## AC-23-05

# River Bridge Ranch Block Perimeter Alternative Compliance

Hold a public hearing and consider a request by LJA Engineering on behalf of Lennar Homes of Texas for an Alternative Compliance to the maximum block perimeter requirements in Section 3.6.2.1 of the Land Development Code for a proposed plat generally located southeast of the intersection of FM-110 and Staples Rd. (J. Cleary)

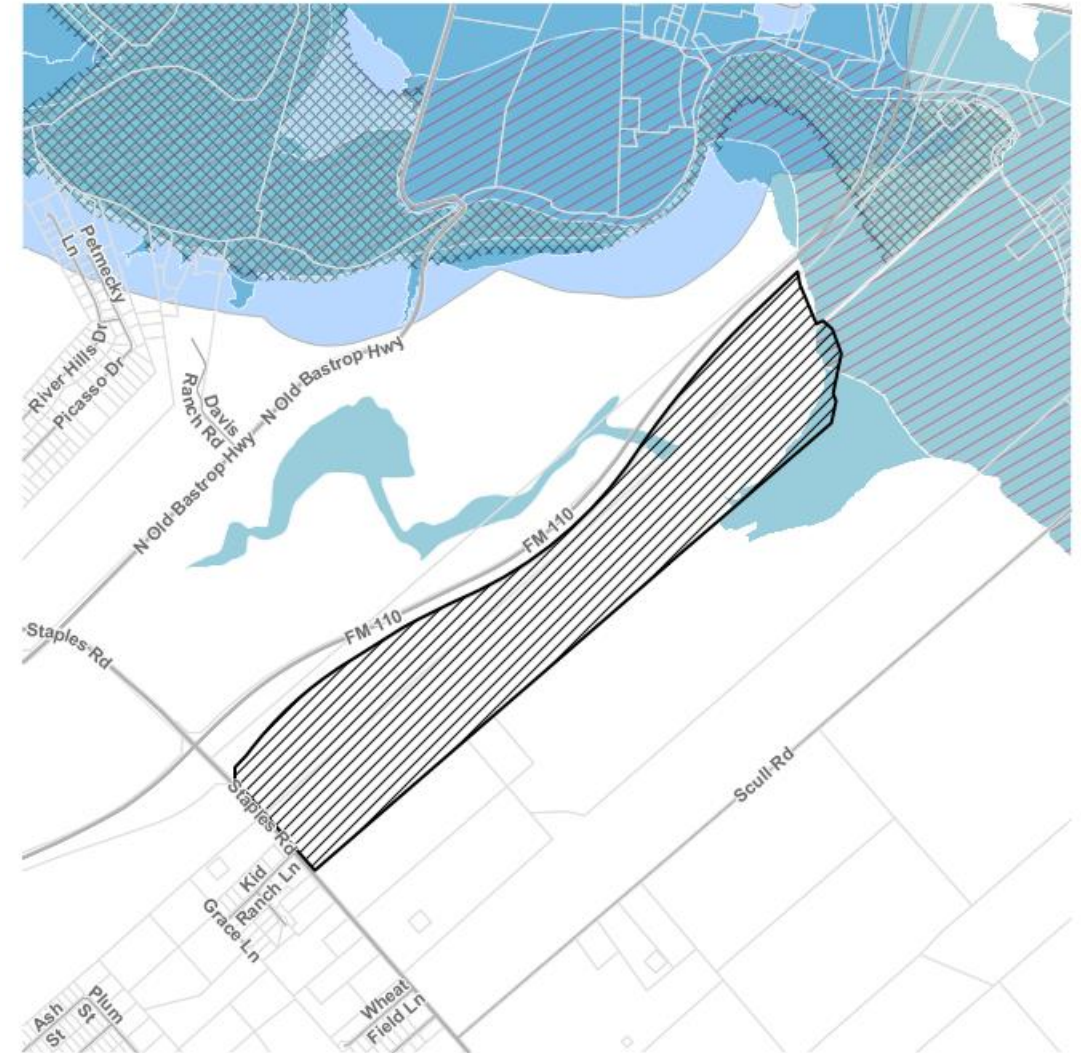
- Development must meet the block perimeter maximum requirement during platting (2,800 feet for CD-3).
- A block is bounded by an improved public right-of-way, not including an alley.
- Applicant is requesting to waive the maximum block perimeter requirement (the largest block perimeter would be approx. 7,500ft)
- Constraints:
  - TxDOT access management;
  - Proposed drainage and open space within southern part of site.

Approx 7,500 ft

Staff recommends approval of the request with the following conditions:

1. Sidewalks, thoroughfares, open space and public access easements shall be provided in manner which is substantially similar to the submitted block perimeter exhibit.
2. A 12' shared use path shall be provided within the 35' multi use greenway lot along FM 110 and along Staples Rd.
3. All lots annotated as "Open Space for pedestrian access" on the block perimeter exhibit shall include a pedestrian passage with a 10' sidewalk per Section 3.7.2.6.C of the current Land Development Code which connects the opposing block faces.
